कार्यालय प्रमाणीय वनाधिकारी, उत्तरकाशी वन प्रभाण, उत्तरकाशी E.Mail. dfouttarkashifd@gmail.com Fax No-01374222964 Tel.No- 01374222444 प्रांक- 1252 / 12-127, कोटबंगला दिनांक 10 //0/2017

विषय :- प्रपोजल संख्या-FP/UK/ROAD/20179/2016 जनपद उत्तरकाशी में विकास खण्ड चिन्यालीसौड़ के अन्तर्गत मल्ली-बधाण गांव मोटर मार्ग के थौला से माड़ मोटर मार्ग निर्माण के सम्बन्ध में।

मल्ली - बधाणगांव मोटर मार्ग से थौला से माड़ मोटर मार्ग के निर्माण हेतु चयनित क्षतिपूरक वृक्षारोपण स्थल

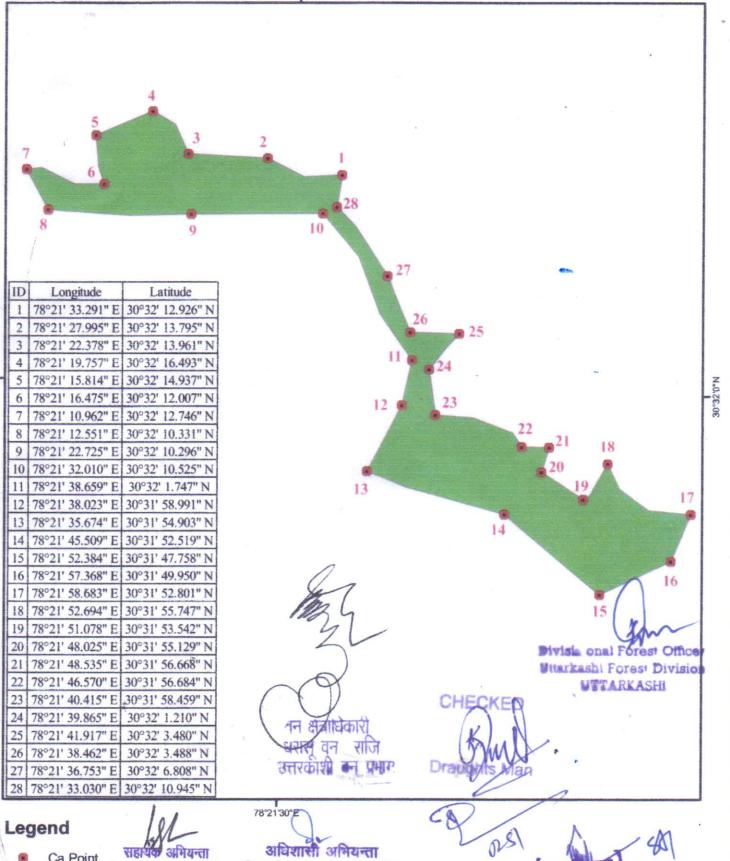
8	The State Govt provided CA scheme for equivalent land which is not accepted. The State Govt may provided CA scheme for double the area being diverted and revised the information in online Part-I column L and II column 13 accordingly with revised georefrenced map, KML file, and site suitability certificate.	The CA scheme land bing diverted doublé area.	
9	24 trees per hectare does not account for 0.4 density. The State Govt may review the density and correct the NPV rate accordingly.	The density is 0.4 and the NPV rates aer correct according to the density.	
10	Original copy of the revised document should be furnished to this office.	Original copy of the revised document are attached.
